## **Important Safety Recall**

**Recall Number: 23V-327/Transport Canada 2023-356**

**Subject: Atlas E1 BAT (Battery) Circuit Connection**

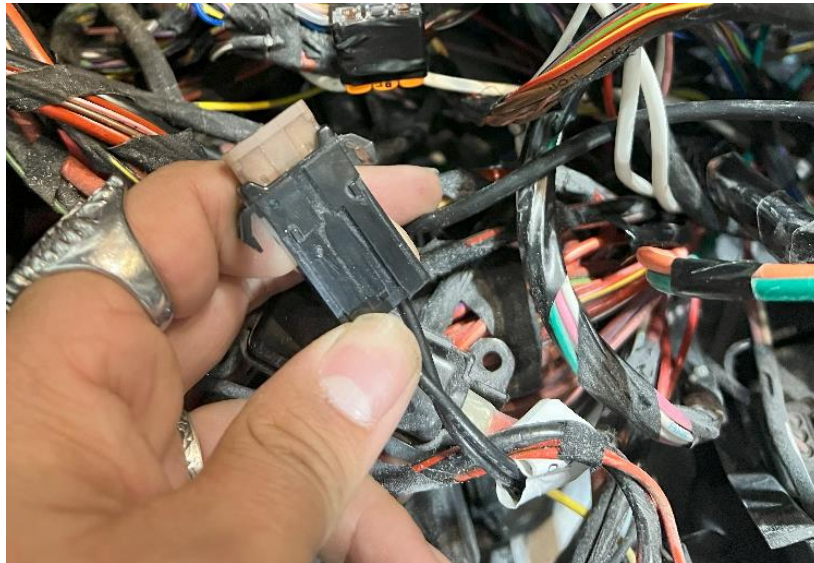
9. Back under the driver's seat, locate the inline fuse on the fuse panel that is labeled "20-amp." Replace the 20-amp fuse with a new 5-amp fuse. Make sure to replace the 20-amp label with a new 5-amp label as well.

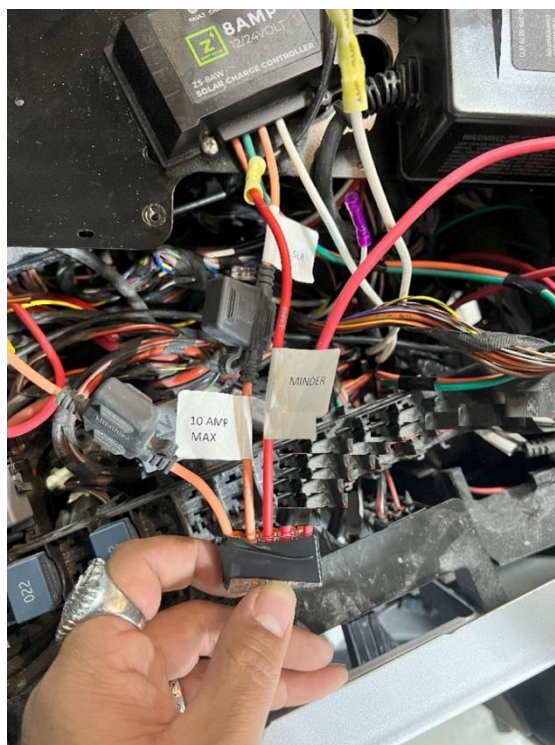
12. The 5-spot Wago connector should look like the image below. The step module and the Timberline system wires will still need to be routed and connected.

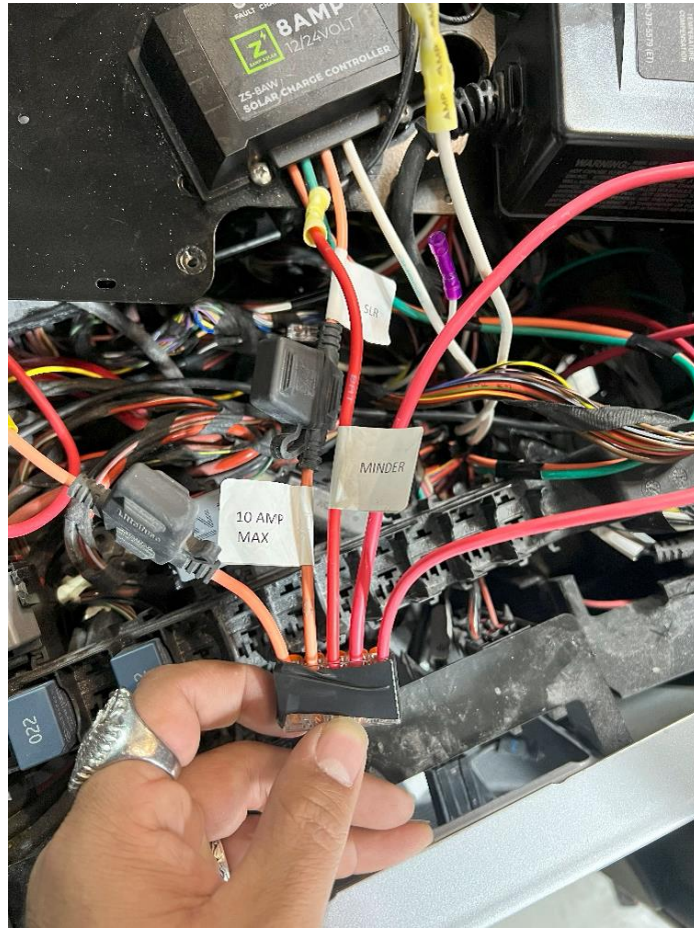
19. When the new wiring is complete, the 5-spot Wago connector should be wired as seen in the image below.
